TENNESSEE VALLEY AUTHORITY

In the Matter of the Application of) Docket Nos. 50-327
Tennessee Valley Authority) 50-328

Enclosed are response to the Materials Engineering Branch (MEB) questions on preservice and inservice inspection transmitted by S. A. Varga's letter to N. B. Hughes dated December 8, 1978.

5.29 Specific Areas Identified in the Review which may Require Relief

Figure Q5.9-7

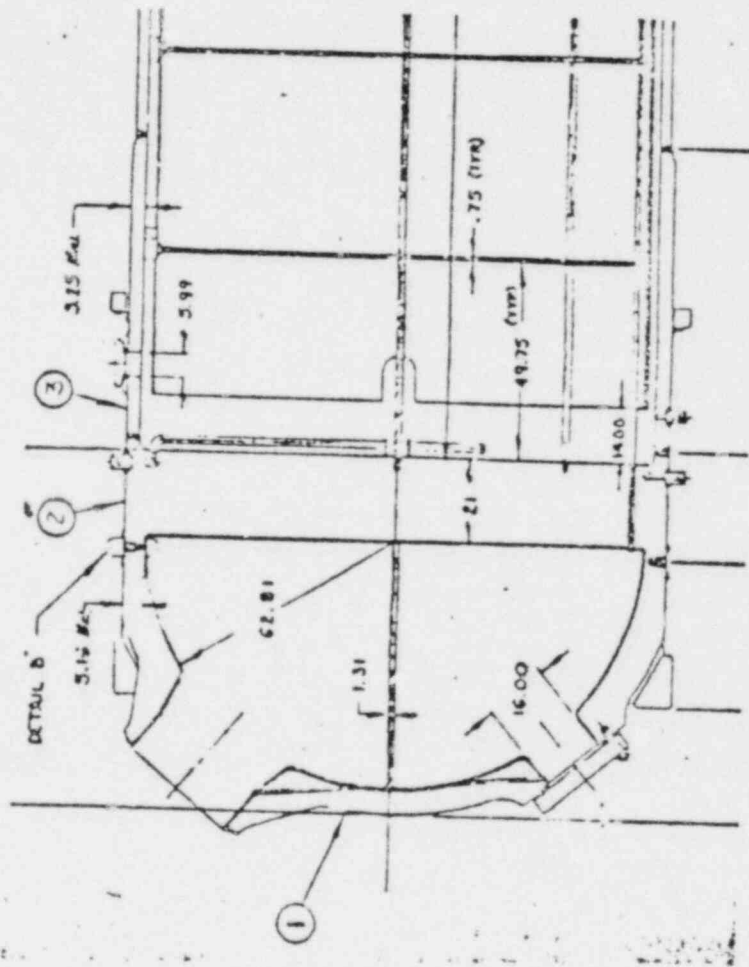
- I. Components
Steam generator nozzle.
- II. Exception Taken
Volumetric examination of nozzle inside radius section on the primary side (examination category B-D) will not be made.
- III. Justification
Each steam generator consists of two integrally cast nozzles and two integrally cast manways. The present capability of ultrasonic testing is not sufficient to examine cast material of this thickness and achieve meaningful results. (See figure Q5.9-7.)
- IV. Testing in Lieu of Section XI Requirements
None.

Figure Q5.9-8

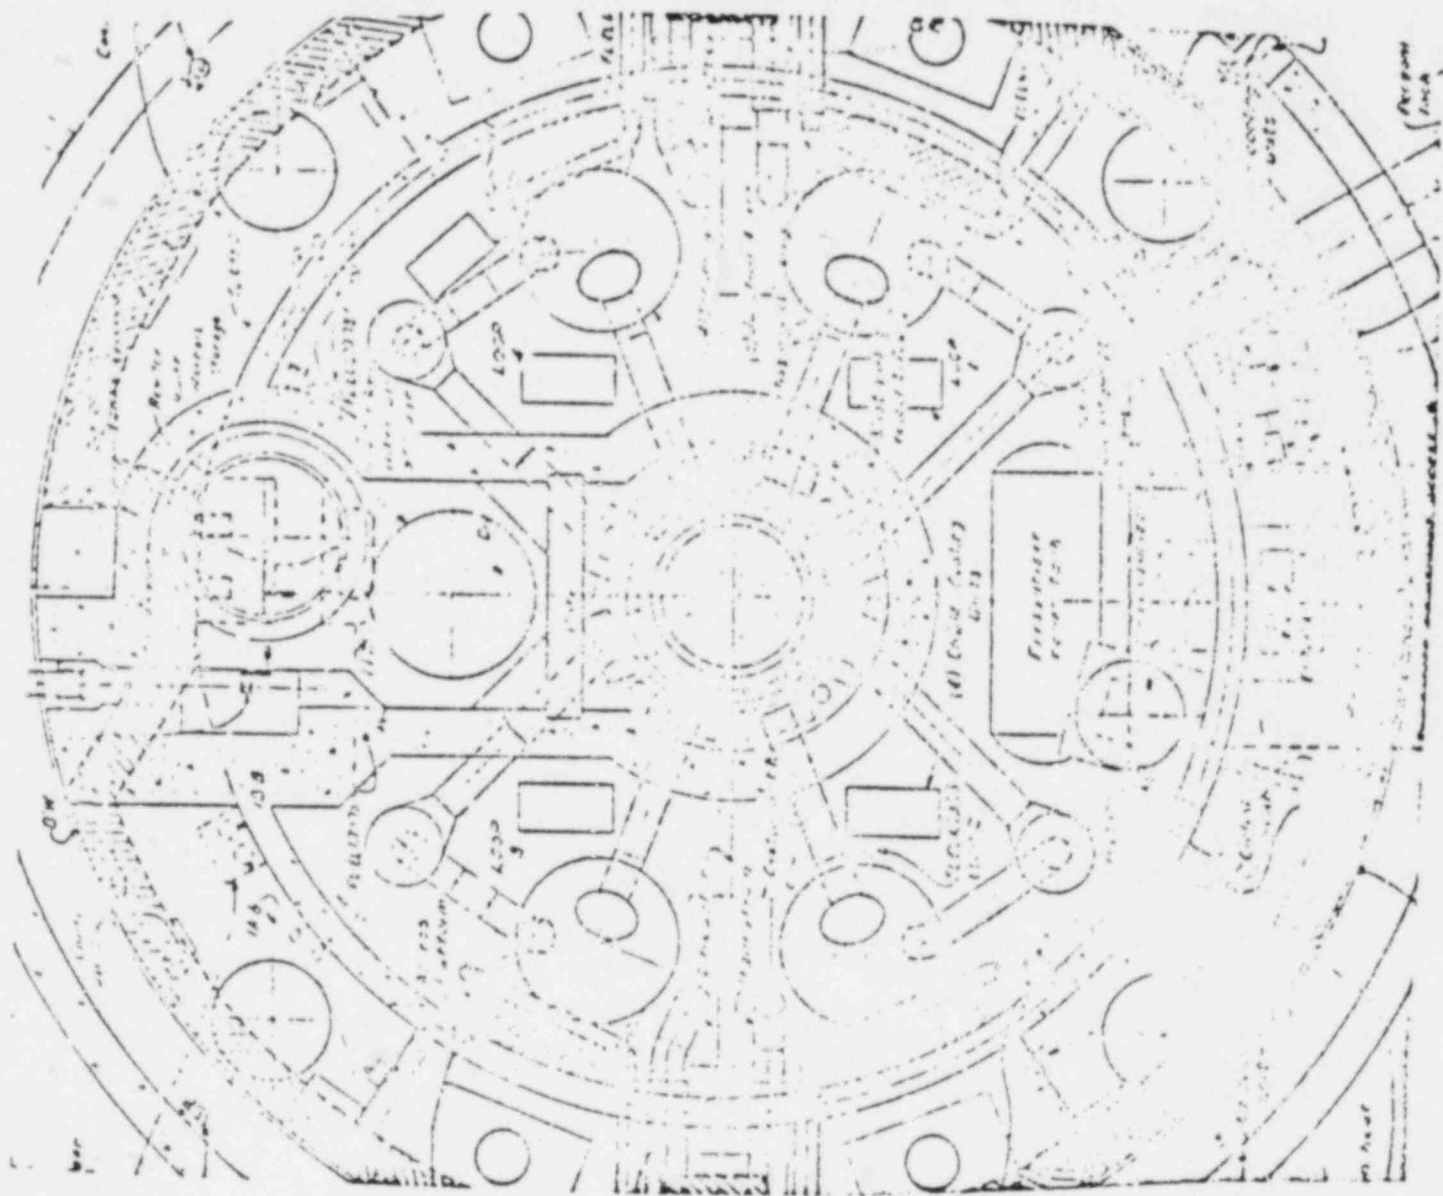
Two circumferential welds in the reactor coolant loop piping (RC-2351 and RC-3151, loops 3 and 4) are located inside the reactor vessel shield wall and are inaccessible for baseline and inservice examination (see figures Q5.9-8 and Q5.9-9). Both welds have undergone shop radiographic examinations. Since the baseline inspection serves as a reference to future inservice inspections and both welds will be inaccessible for inservice inspections, the shop radiographic examination coupled with the Section III hydrostatic test will provide adequate proof of integrity of the system welds. Inservice system leakage and hydrostatic testing will prove weld integrity during the life of the plant.
